No. EL/3.1.35/12

MODIFICATION SHEET No. RDSO/2023/EL/MS/0493 Rev. '0', Dated July 2023

1.0 Title: Provision of Additional safety sling for Traction Link of WAP5/WAP7/WAG9 Locomotives.

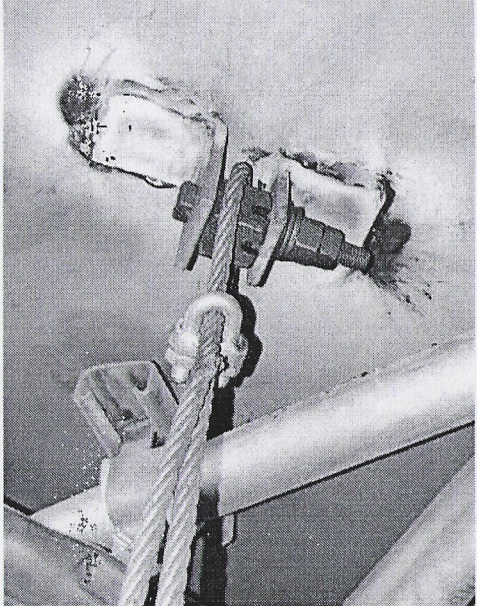
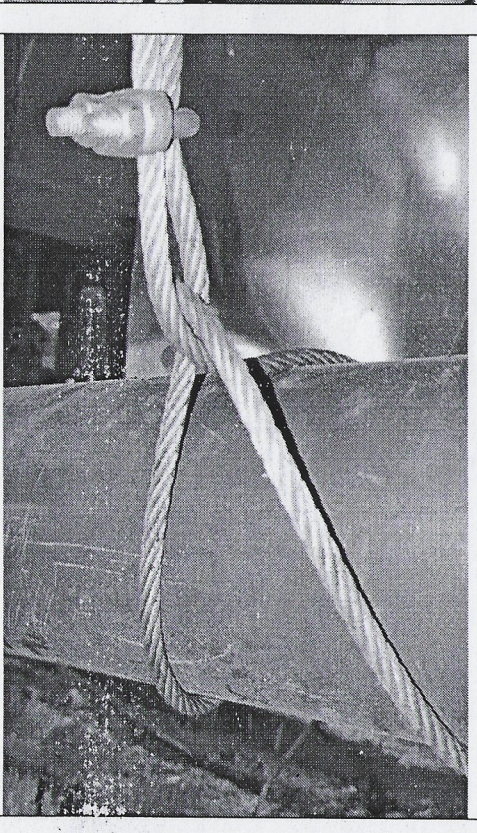
2.0 Object: Railways have reported cases of falling of Traction Link of WAP5/WAP7/WAG9 Locomotives due to breakage of traction link bolts. As per original design, there are two safety slings provided, one at either ends of traction link to prevent falling of traction link. However, in case of breakage of traction link bolts, if any of safety slings fails, traction link will fall on ground and this may lead to untoward incident. So, it is felt necessary to provide Additional safety sling to give more safety to Traction link. In TC-142 issued by RDSO for reliability action plan, it was instructed to provide additional safety sling. Some of the zonal railways are already providing Additional safety sling in the traction link. CLW requested RDSO for details of how additional safety sling should be provided. This Modification sheet covers the general details of provision of additional safety sling in Traction link.

3.0 Existing Arrangement: There are two safety slings provided at either ends of traction link to support it from falling down to ground in case of breakage of traction link bolts.

4.0 Modified Arrangement: Additional safety sling as per enclosed RDSO drawing no. SKEL-5076 (Latest alteration) will be provided in the middle position of traction link.

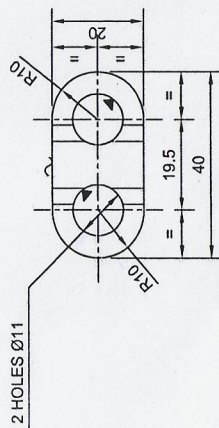
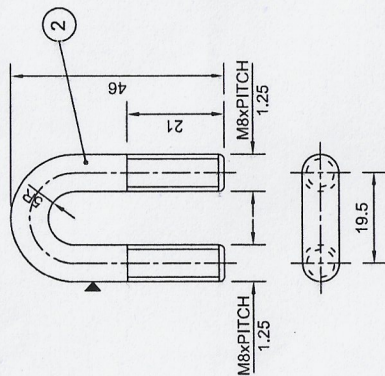
The fixing arrangement of additional safety sling for traction link for 3-Phase Electric Locomotives in pictorial representation is given below.

S. No.	PROCEDURE	IMAGE
1	<p>Weld the L-clamps to the body above the mid position of the traction bar as shown in the picture.</p> <p>Connect one end loop of safety sling to L-clamp with M16x65mm bolt with suitable washer and nut.</p>	
2	<p>Tightly wrap the safety sling on the middle portion of the traction bar as shown in the picture.</p> <p>Ensure that between traction bar and L-clamp there is adequate length the safety sling to allow free movement of traction bar.</p> <p>Secure the safety sling with help of U-clamp (bull dog clamps) as shown in picture. U-clamp (bull dog clamps) should be tightened nearest to wrapping so that wrapping does not become loose in due course.</p>

3	Secure the free end of safety sling with help of U-clamp (bull dog clamps).	
---	---	--

ADDITIONAL SAFETY SLING
(FOR BOGIE TIE ROD)

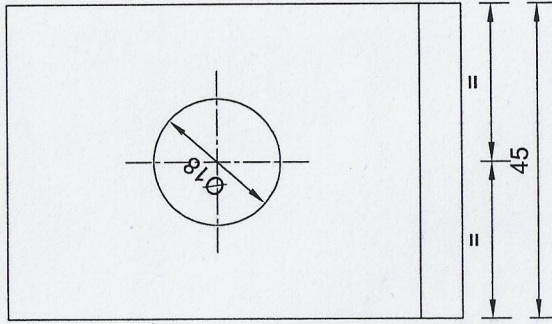
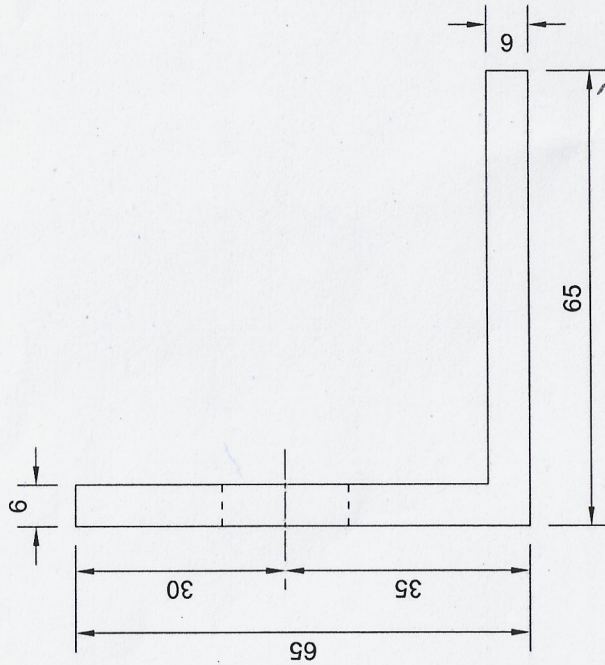
- (iii) U" Bolt with Ref. No. 2 as per RDSO drawing no. SKEL-5076 (sheet 1 of 2) -08 sets
- (iv) H.T. Hex Head bolt of size M16 X 65mm (Threaded Length 40 mm) Pitch-2mm of P.C. 8.8/10.9 as per IS:1364/1367 with suitable nut and flat washers 02 Sets.
- (v) M24 released lock nut at center of L Clamp 02 Nos.
